VIN APPLICATION
ALL with optional
cellular telephone

BULLETIN NO.
93-023

Intermittent Power on Cellular Phone

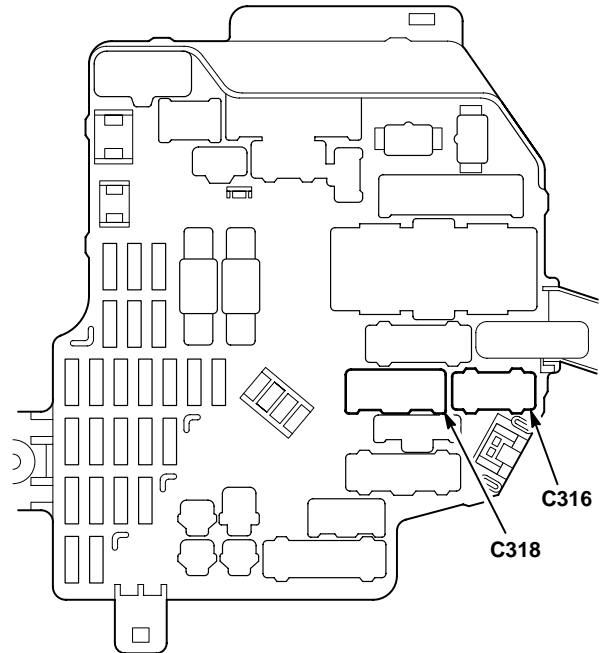
1. Remove the left side cowl lining.

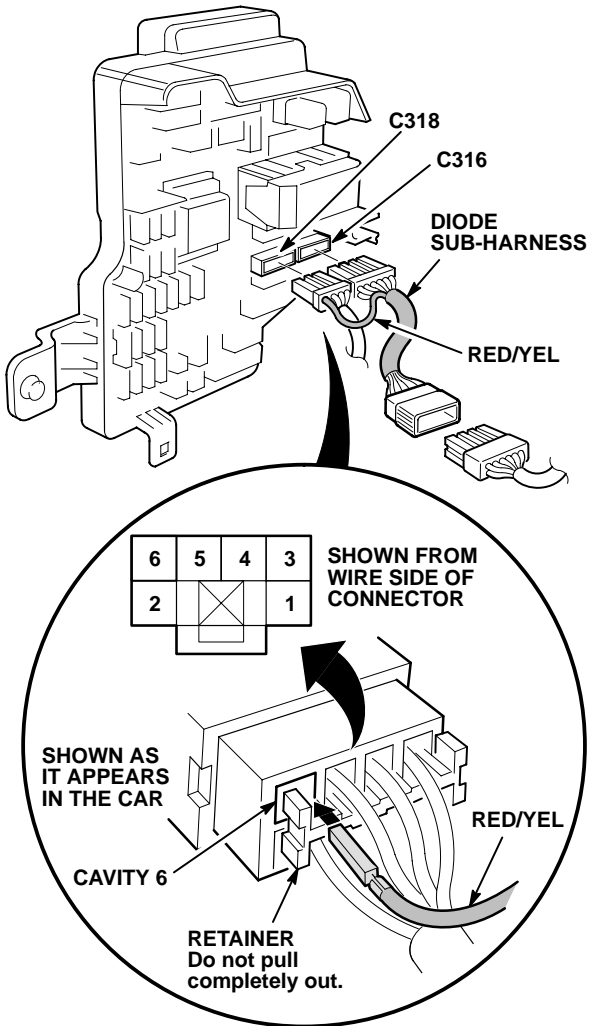
3. Insert the 12-P male connector of the diode sub-harness into the C316 cavity.
 4. Insert the C316 male connector, just disconnected from the fuse box, into the 12-P female connector of the diode sub-harness.
 5. Disconnect the C318 connector from the interior fuse box.
 6. Loosen the terminal retainer on the C318 male connector just enough to insert the loose pin of the diode sub-harness into cavity #6.
- NOTE: Be careful not to pull the retainer all the way out, or you will have to re-thread the connector wires.
7. Push the terminal retainer back in, locking the diode sub-harness pin in place.
 8. Reconnect the C318 connector into the fuse box.

9. Verify operation of the cellular phone during starter operation.
10. Reinstall the left side cowl lining.
